UNITED STATES PATENT AND TRADEMARK OFFICE

Office Action Summary

10/599,876

DETAILED ACTION

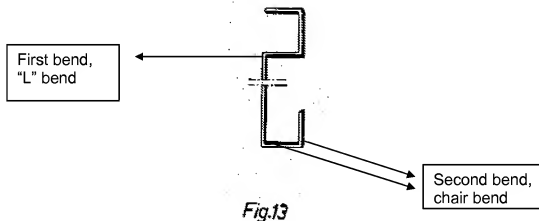
b) bending said sheet of metal along an upper longitudinal edge thereof to produce a first "L-shaped" bend (Lipp, Figs. 8-13, upper edge is bent "L-shaped" to produce first bend);

c) bending said sheet of metal along a lower longitudinal edge thereof to produce a second "chair-shaped" bend, wherein the term "chair-shaped" means a structure that has two parallel, elongated sheets of metal extending out on either side joined by a cross member with the angle between either sheet and the cross member being at least 45 degrees (Lipp, Figs. 8-13, lower edge is also bent to produce second bend; the bottom two bends form a chair bend with two parallel lines and one cross member);

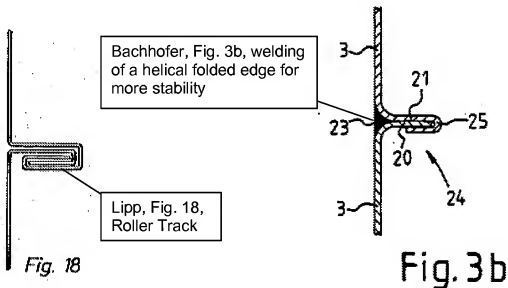
e) welding said second bend to said first bend to form a wall of said tank, said wall having a continuous, leak-tight helical weld; Lipp only teaches a continuous helical wall where the edges are folded (Lipp, Fig. 18).

However, Bachhofer discloses (DE19939180 DERWENT Abstract, title, lines 7-10) a cylinder container tank formed by sheet strip and the sheet strip is spirally formed where the edges are bent out at the butt line to be welded together. Bachhofer also discloses (Fig. 3a and Fig. 3b) that the welding (Fig. 3b) is done to the joint after the edges are folded (Fig. 3a) together. Bachhofer explains that the welding is done to provide stability (English Abstract, title, lines 7-10). It would have been obvious for one having ordinary skill in the art at the time the invention was made to further weld the folded joint (Lipp,

Fig. 18), as suggested by Bachhofer (Bachhofer, Fig. 3b) in order to provide more stability to the joints (shown in figure 18 above) in a circular metal tank of Lipp.

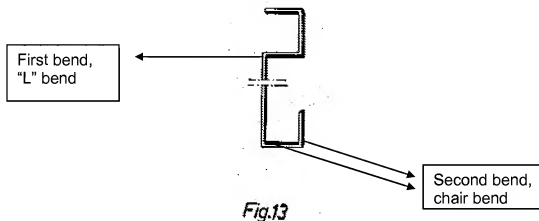
wherein said first and second bends cooperate to form a helical roller track on an outside of said tank (Lipp, Fig. 18, first and second bend is folded to provide a roller track that rests on support rollers 7 in Fig. 20); and

wherein said tank is supported on a plurality of rollers (Lipp, Fig. 20, support rollers 7 engage the roller track of Fig. 18) that engage said roller track;

and wherein said tank is rotated about its longitudinal axis on said rollers (Lipp, column 6, lines 46-51, "... supporting rollers ... supporting the tube at a fold therein, said helical path and said tube supported thereon having substantially vertical longitudinal axes" Here said 'fold' is shown in Fig. 18 above, 'supporting rollers' 7 are shown in Figs. 1 and 20) such that said tank moves upwards as said sheet of metal is welded to bottom thereof (Lipp, column 1, line 16, "... produced from the ground up").

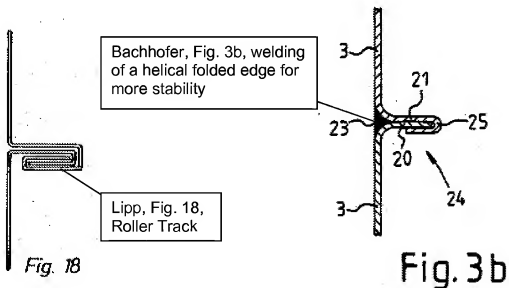
(e) a welder for welding said first and second bends together to form a circular wall of said tank; Lipp only teaches a continuous helical wall where the edges are folded (Lipp, Fig. 18).

However, Bachhofer discloses (DE19939180 DERWENT Abstract, title, lines 7-10) a cylinder container tank formed by sheet strip and the sheet strip is spirally formed where the edges are bent out at the butt line to be welded together. Bachhofer also discloses (Fig. 3a and Fig. 3b) that the welding (Fig. 3b) is done to the joint after the edges are folded (Fig. 3a) together. Bachhofer explains that the welding is done to provide stability (English Abstract, title, lines 7-10). It would have been obvious for one having ordinary skill in the art at the time the invention was made to further weld the folded joint (Lipp, Fig. 18), as suggested by Bachhofer (Bachhofer, Fig. 3b) in order to provide more stability to the joints (shown in figure 18 above) in a circular metal tank of Lipp.

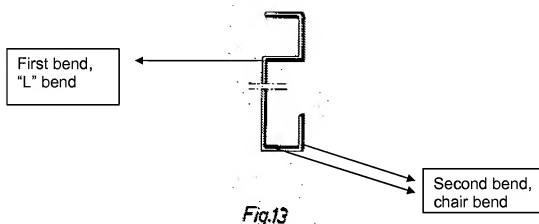
wherein said first and second bends cooperate to form a helical roller track on an outside of said tank (Lipp, Fig. 18, first and second bend is folded to provide a roller track that rests on support rollers 7 in Fig. 20);

and wherein said tank is supported on said rollers that engage said roller track (Lipp, Fig. 20, support rollers 7 engage the roller track of Fig. 18).
